CIVIL AVIATION AUTHORITY OF NEW ZEALAND

AIRWORTHINESS DIRECTIVES

Amendment Nr 26-09

Effective date 24 September 2026

Figure 1 - Inspection Location

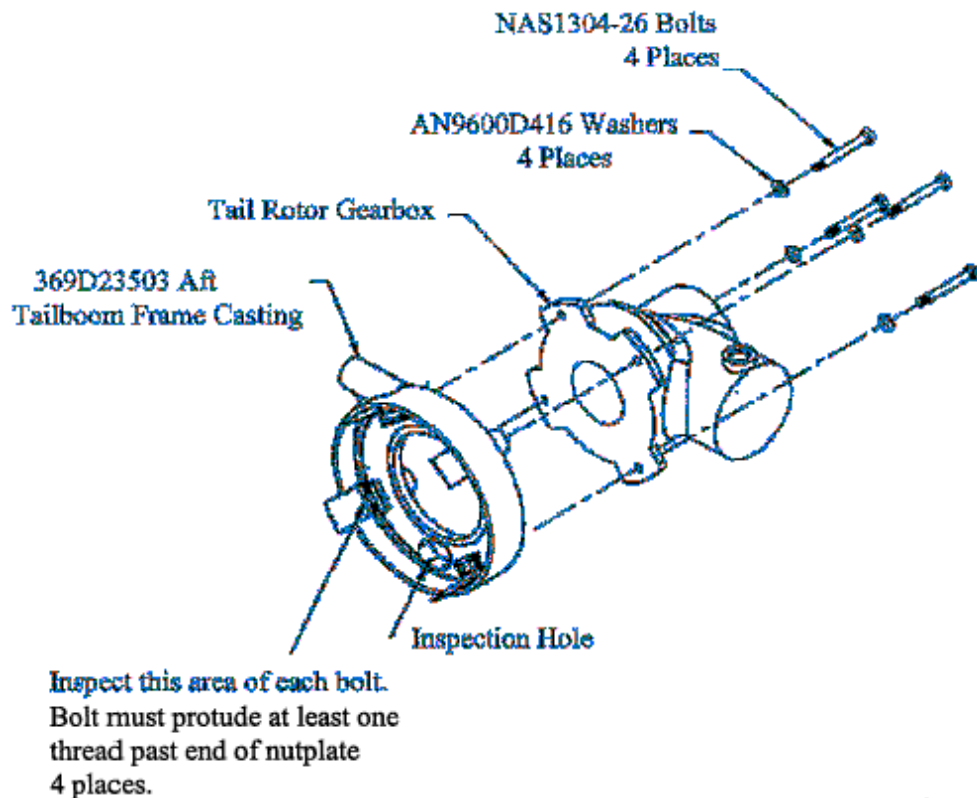
Requirement: To prevent loss of the tail rotor gearbox due to attaching bolts of inadequate grip length and subsequent loss of helicopter control, accomplish the following:

1. Determine the P/N of each tail rotor gearbox attaching bolt. If the P/N cannot be determined or if the bolt is not P/N NAS1304-26, replace with bolt, P/N NAS1304-26, before further flight. Torque the bolt to 100-110 in-lbs and apply a slippage mark.
2. Remove the tailboom control rod and determine the number of bolt threads protruding from each nutplate on the internal surface of the aft tailboom frame casting, P/N 369D23503, as shown in Figure 1 of this AD. At least one thread must protrude. If more than four threads protrude, add an additional washer, P/N AN960D416, under the bolt head. Torque the bolt to 100-110 in-lbs, and reapply a slippage mark.

3. Between 2 and 10 hours TIS after accomplishing the requirements of paragraph 2 of this AD, inspect the torque on each bolt by applying 100 in-lbs. If any bolt movement occurs, retorque the bolt to 100 -110 in-lbs. Reapply a slippage mark after torque check and reinspect the torque between 2 and 10 hours TIS thereafter until no bolt movement occurs.
